ON LINE UPDATE

MUL-T-LOCK®

NO.217

Thumbturn update

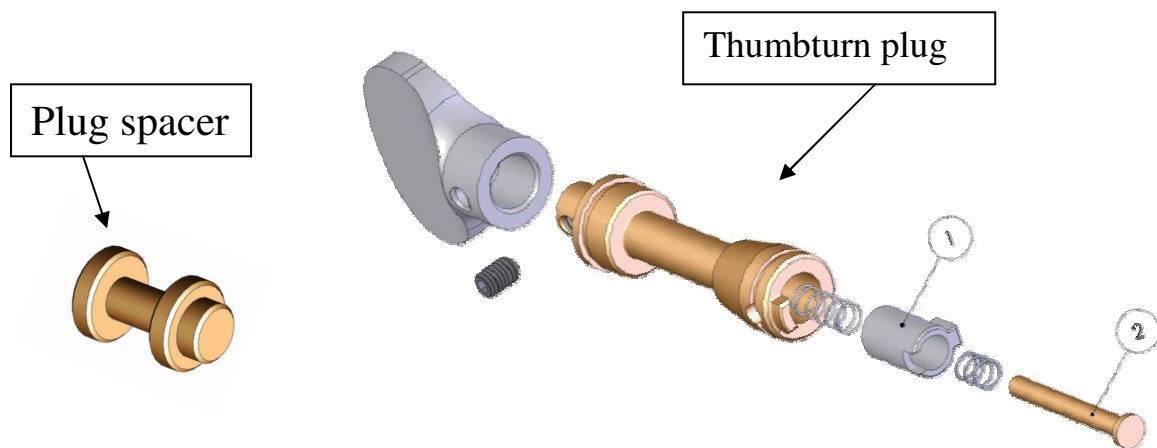
In the good spirit of saving highly valuable raw material – we have modified our thumb turn plugs, and the euro cylinders spacers...this is a very visual change – but without any effect on function and not even logistics, as all part will continue to be fully compatible.

We do want to take this opportunity and remind all that the center stopping pin "2" comes in one length for all with the exception of the different between the key side being of the 33 or 35 mm basis – for the 35 mm a thicker head one should be used.
